PROPOSED DIAGRAMS
(and associated text update in spec)

PROPOSED DIAGRAMS
(and associated text update in spec)

Baseboard Hot Plug Support Example

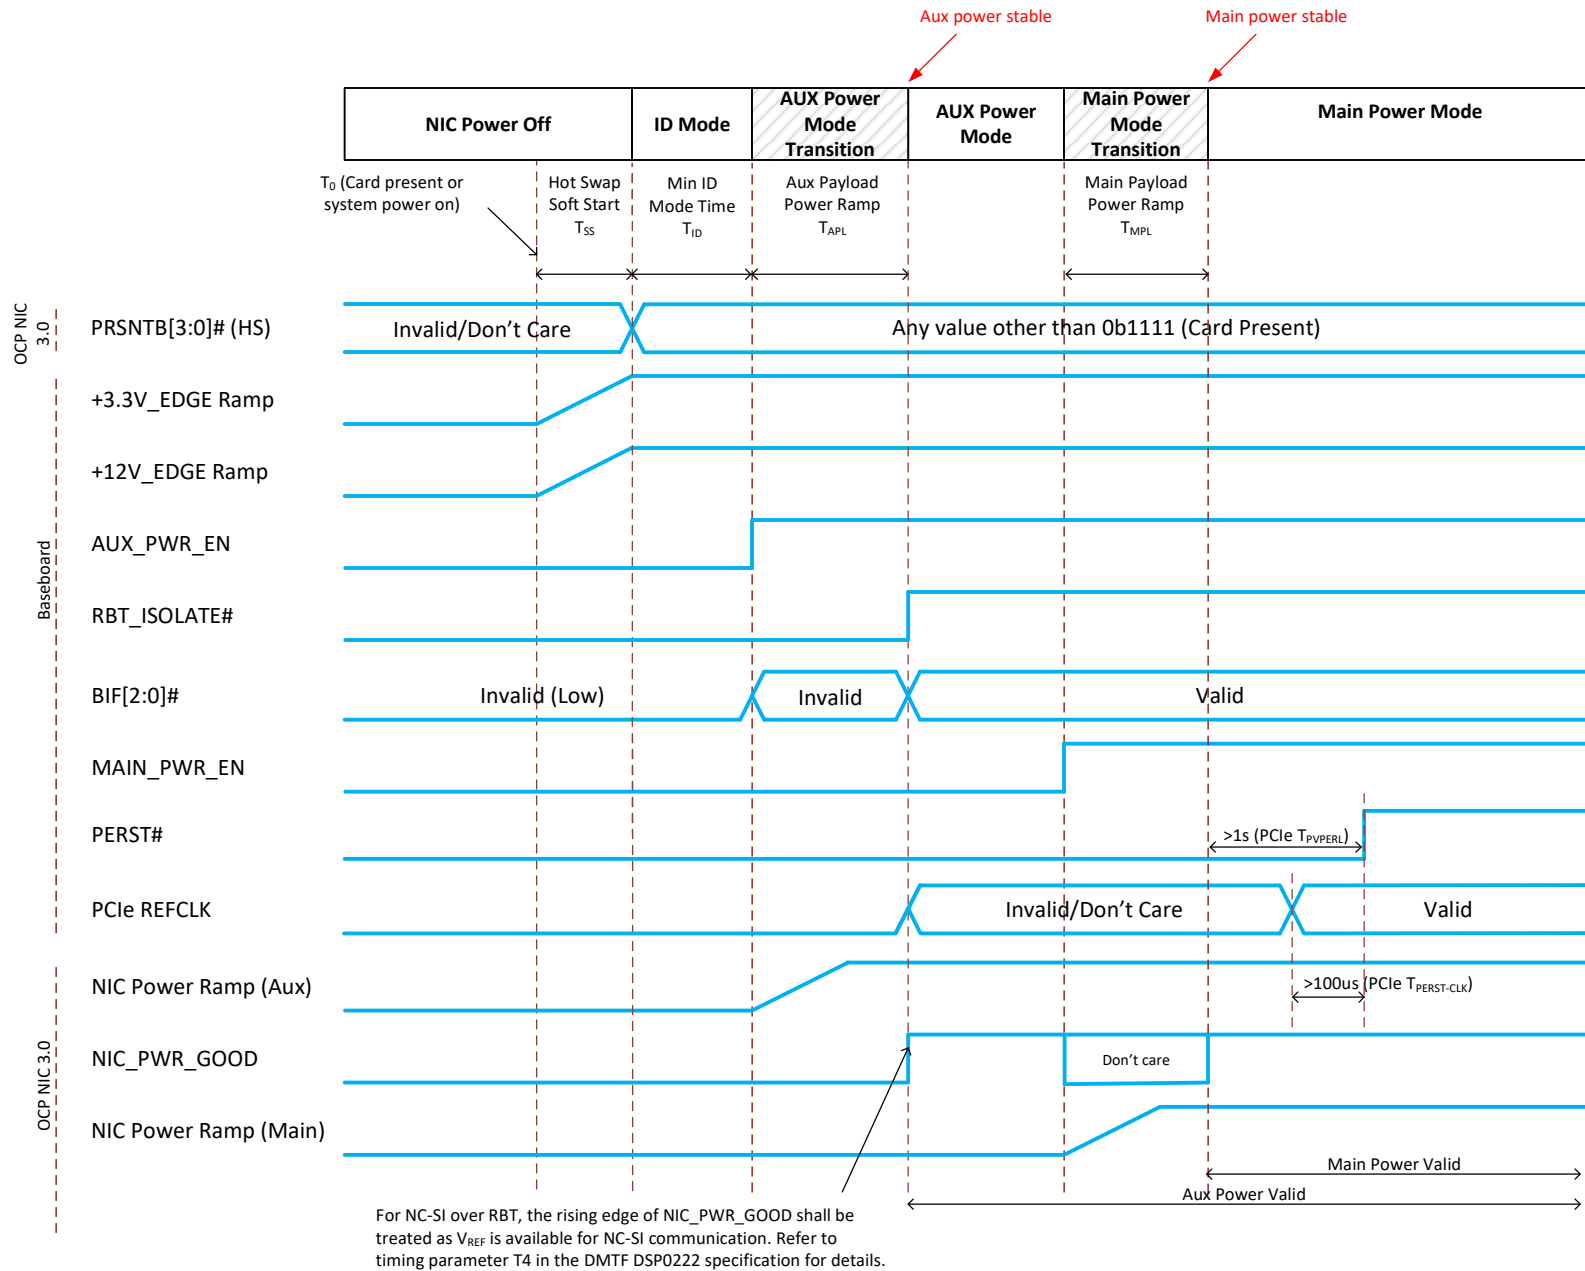
Change history:

0v84 20180919 – Add RBT_ISOLATE# signal

0v84 20180926 – Changed BIF[2:0]# LOW prior to AUX_PWR_EN; add transition state prior to fully entering aux power mode.

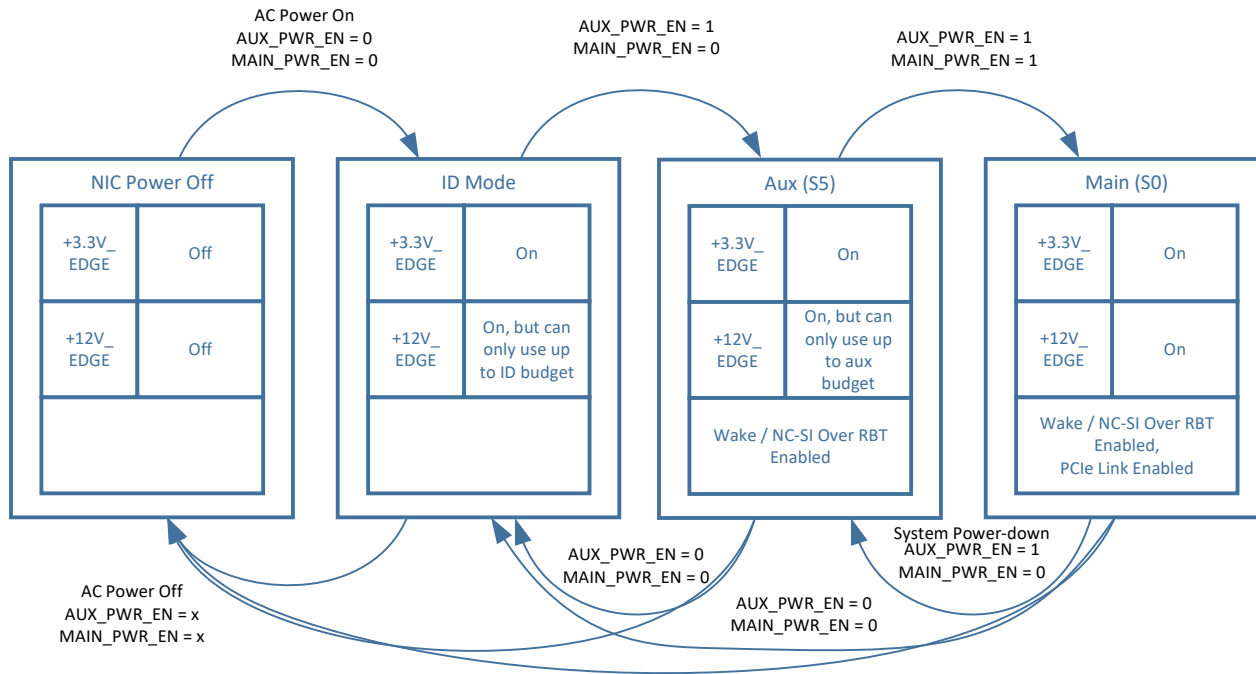
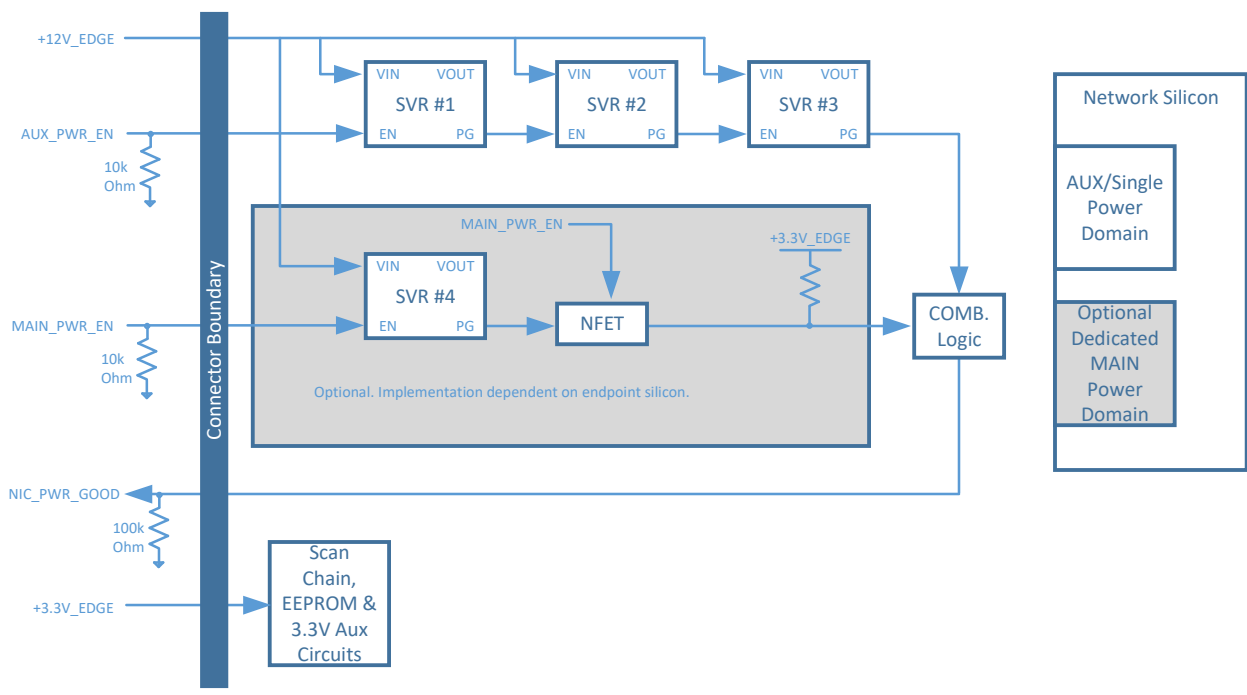
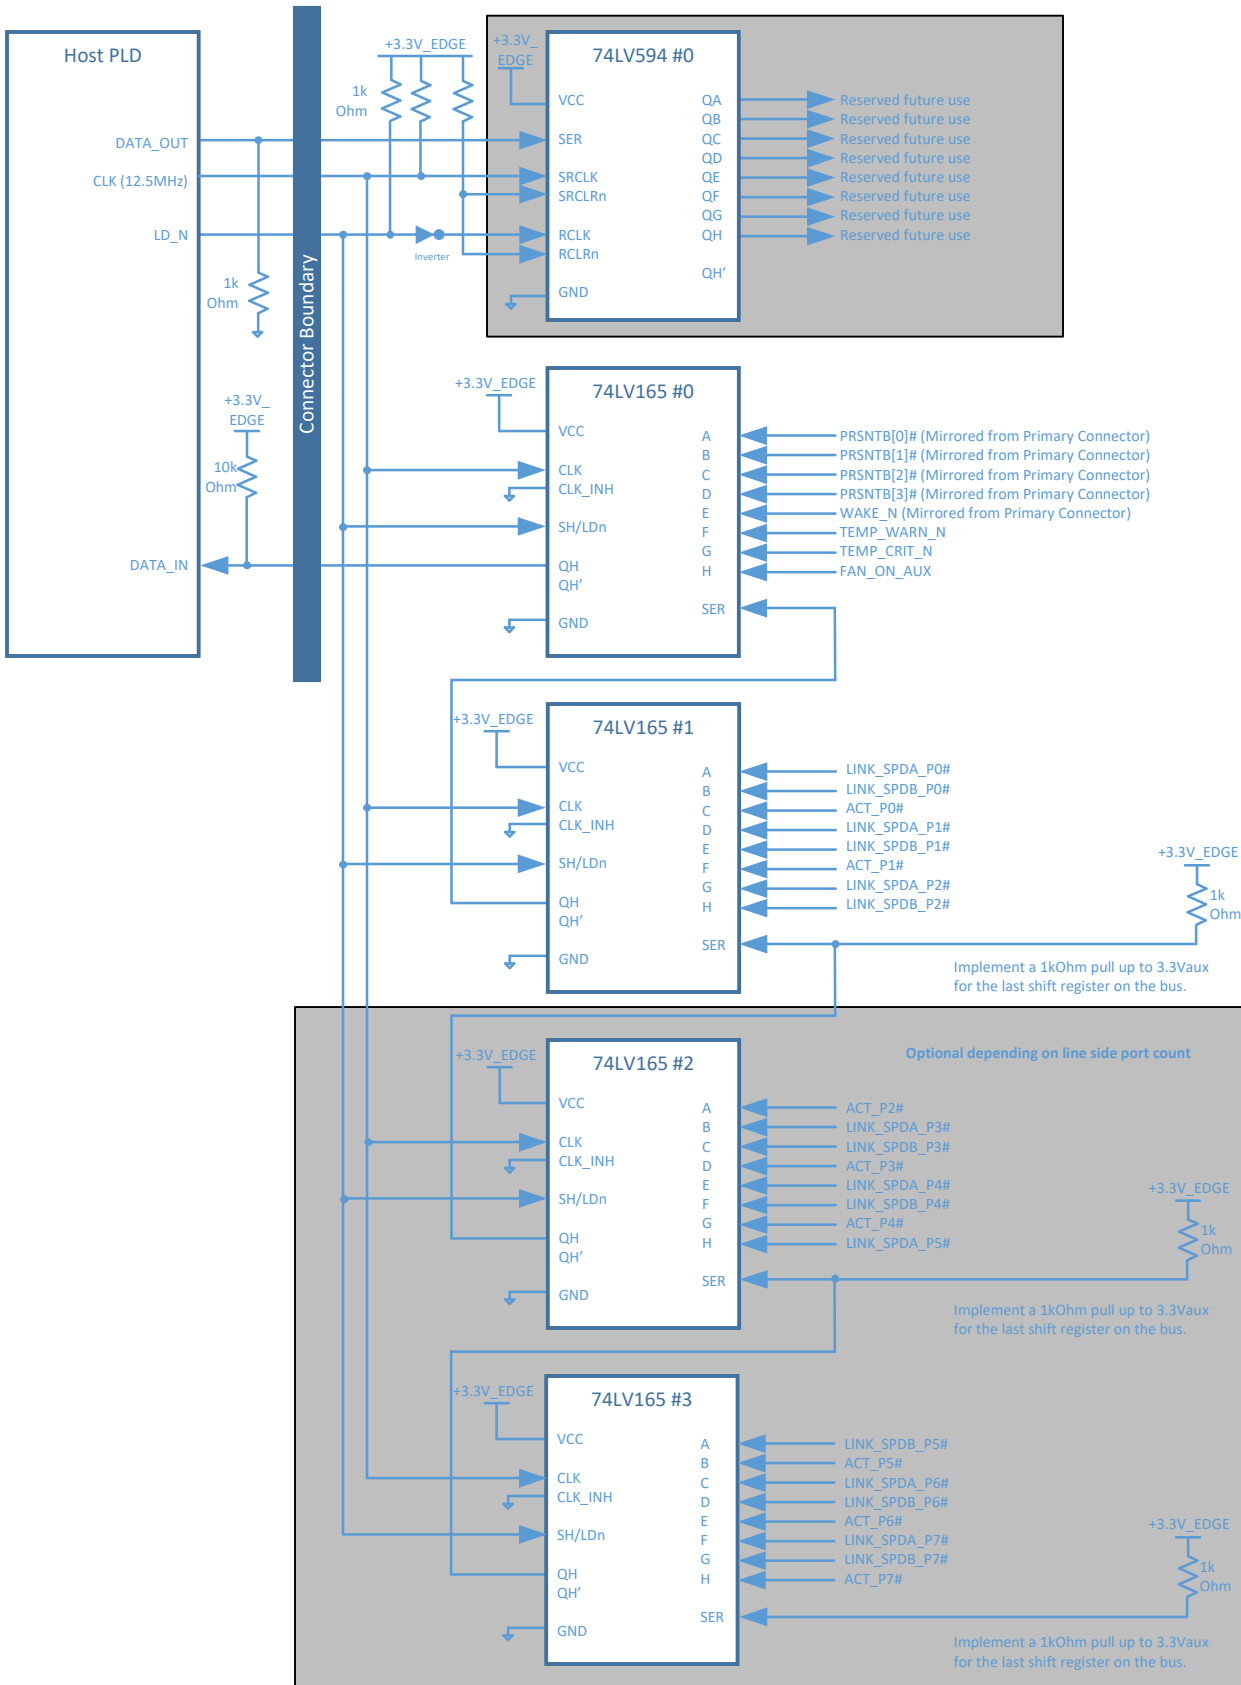
Change history:

0v84 20180919 – Add RBT_ISOLATE# signal

0v84 20180926 – Changed BIF[2:0]# to invalid (low) after AUX_PWR_EN deassertion.

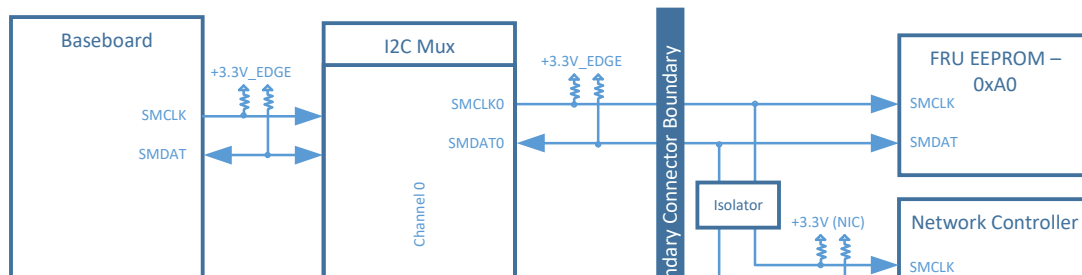
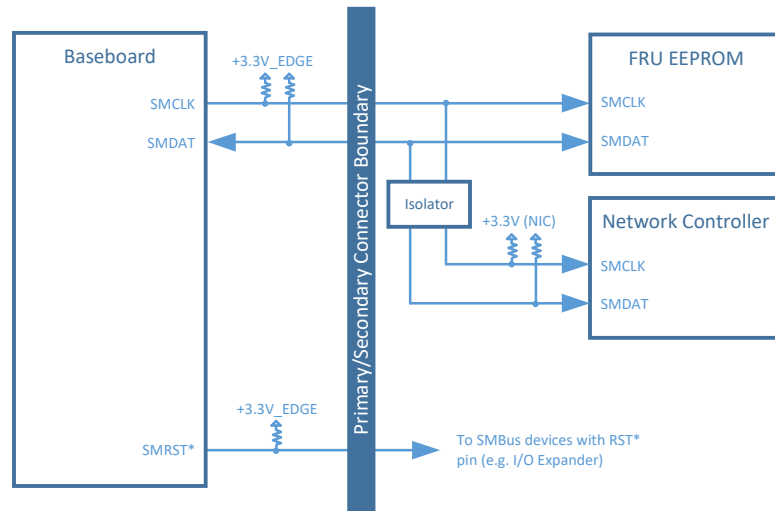
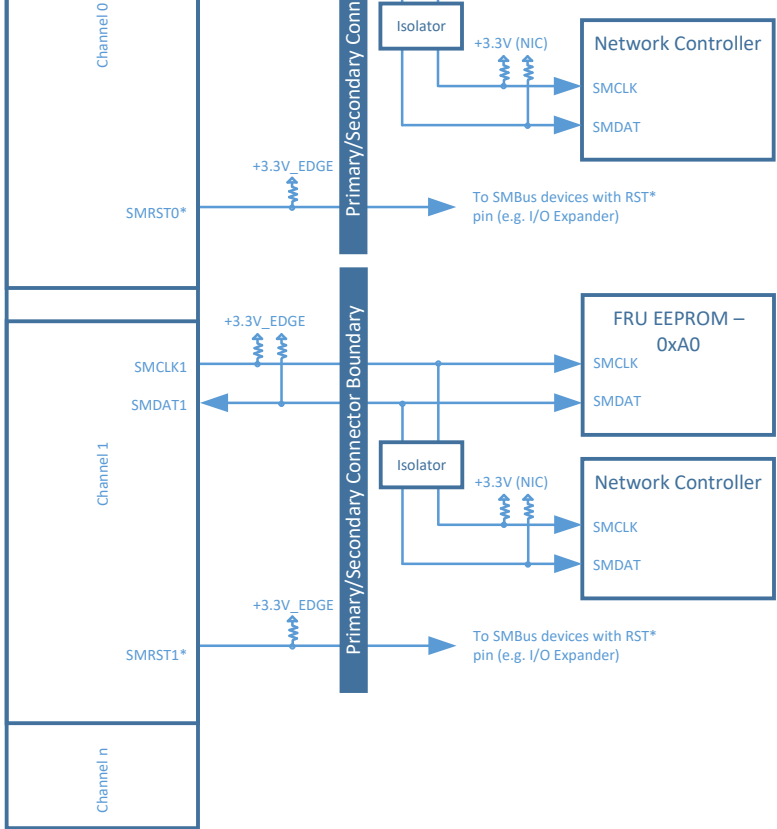
Updated 20180507a-TN – Add DATA_OUT bit 0 definition for SLOT_ID1

Updated 20180508a-TN – Update LED bit ordering to optimize dual port applications

Updated 20180525b-TN – Remove SLOT_ID1 from DATA_OUT (pin redefined on OCP_A6)

Updated 20180604b-TN – LED ACT/LINK pins are active low. Updated names with “#”

UART Block diagram

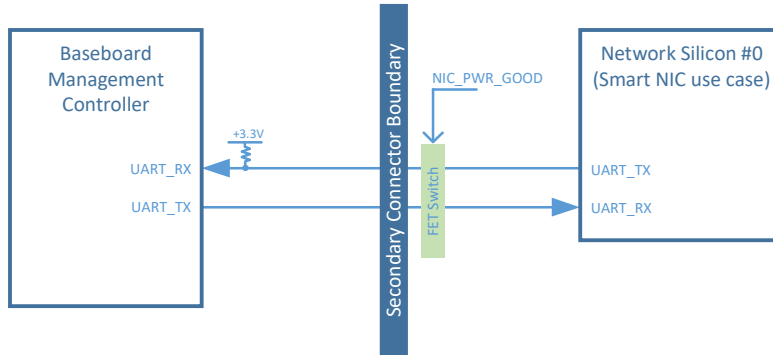
Updated 20180515b-TN – Diagrams copied
- Add UART

Updated 20180525b-TN – Diagrams copied
- Move UART buffer to the NIC side for c

USB 2.0 Block diagram

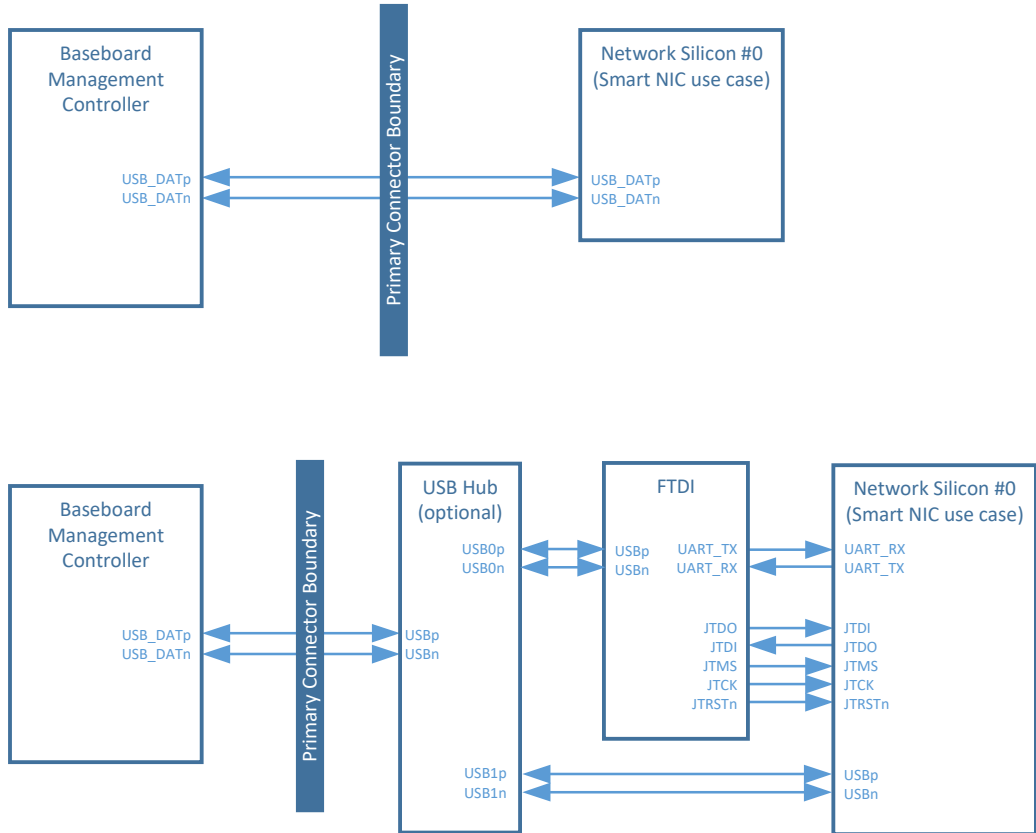
Updated 20180525b-TN – Diagrams copied

- Add USB 2.0 with buffer to the NIC side

Updated 20180705a-TN – Diagrams copied

- Add both diagrams to 0v81 since the USB
